TECHNICAL BULLETIN

Group 3D – Sports Sedans

To update the Group 3D Sports Sedan technical regulations in accordance with recommendations of the National Australian Sports Sedan Association.

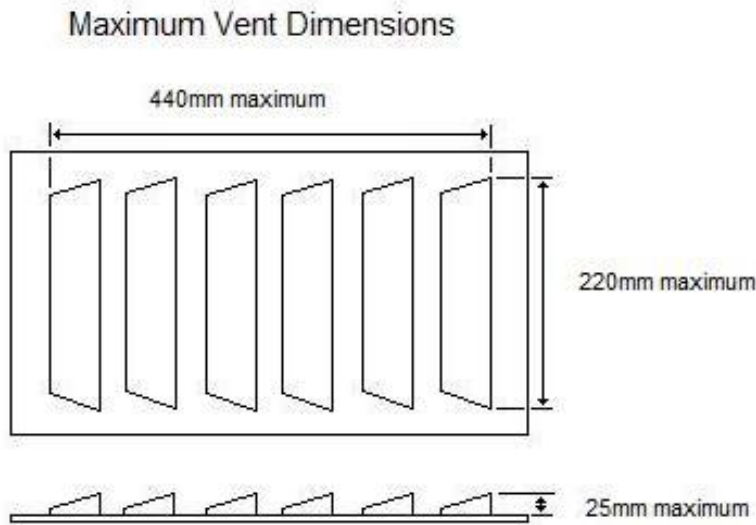
“3.6 (viii) Bonnet and mudguard air extraction: Where the original vehicle has no bonnet or front mudguard air outlets for extraction of air from under the bonnet and or front mudguard area, or if the original outlet/s is less than 500 square centimeters, then louvred venting may be added to the bonnet or mudguard/s subject to the following criteria:

- **The maximum area the louvred area/s may occupy is 968 square centimeters;**
- **A maximum of two (2) vented areas may be added;**
- **The maximum height of any part of any vent is to be 25mm higher than the area of the immediately surrounding bonnet or mudguard;**
- **The maximum total width of the vent openings/raised sections is 220mm;**
- **The maximum total length of the vent openings/raised sections is 440mm.**

The following diagram details the maximum dimensions if only one vent is added:
